Tierra Del Este Unit Eighty Nine

City of El Paso — City Plan Commission — 4/4/19 SUSU19-00016 — Major Preliminary

CITY PLAN COMMISSION APPLICATION FOR MAJOR SUBDIVISION PRELIMINARY APPROVAL

ATTACHMENT 2

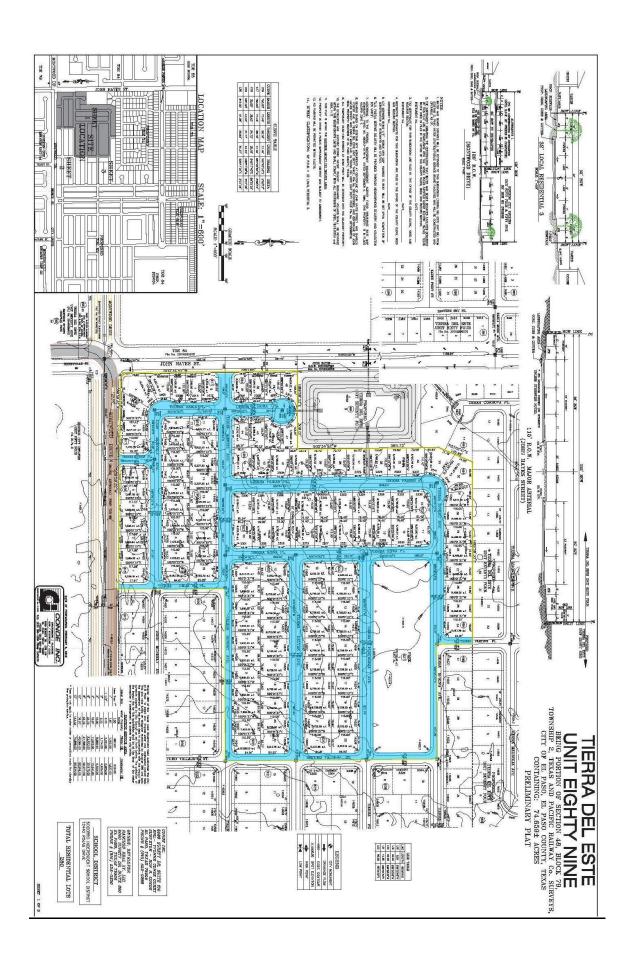
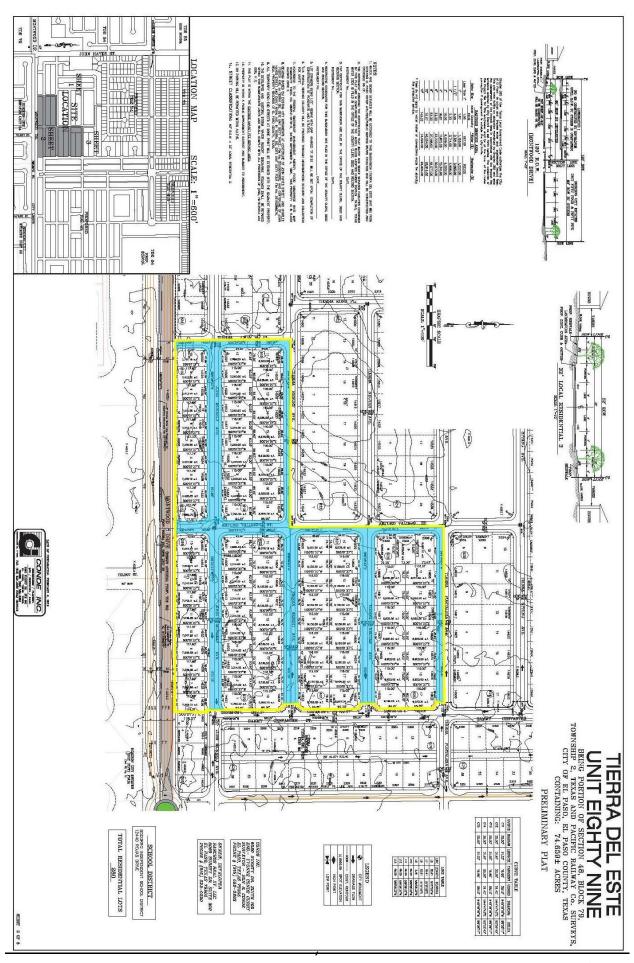
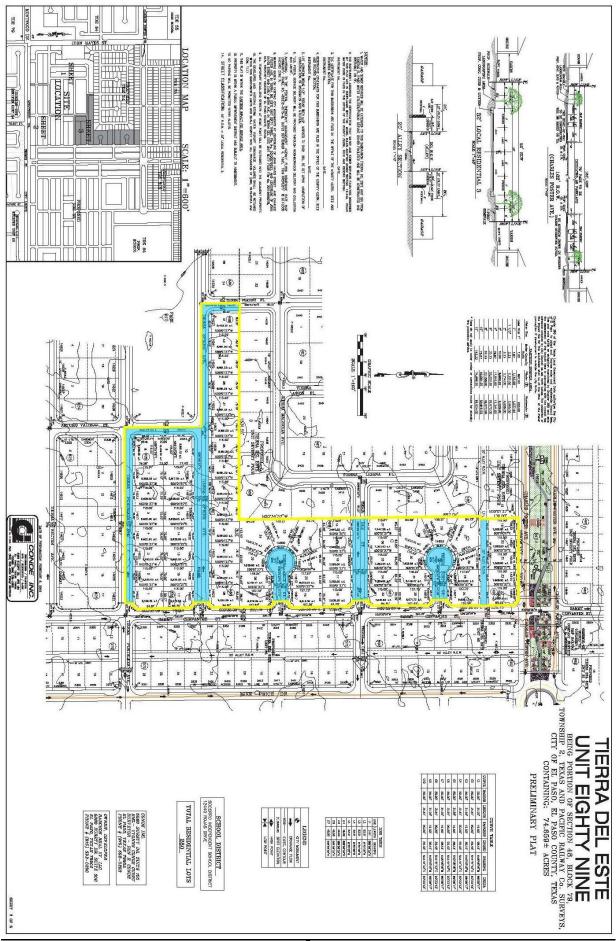
- 1. Show proposed drainage flow patterns on all sheets of the preliminary plat.
- 2. All downstream storm-water management facilities should be in place prior or concurrent to development of the subject subdivision, i.e. Tierra del Este Unit 74 & 83.
- 3. Show existing surrounding drainage flow pattern arrows 200' feet outside subdivision perimeter on the preliminary plat.
- 4. At the improvement plan stage, protect the subject property from storm-water runoff from the adjacent terrain. Define how
- 5. The subdivision shall be tied by bearing and distance to either a section corner, a survey line, a grant line, or other known and accepted survey points this tie shall be delineated on the plat.
- 6. Provide a more visible scale for typical street cross sections.
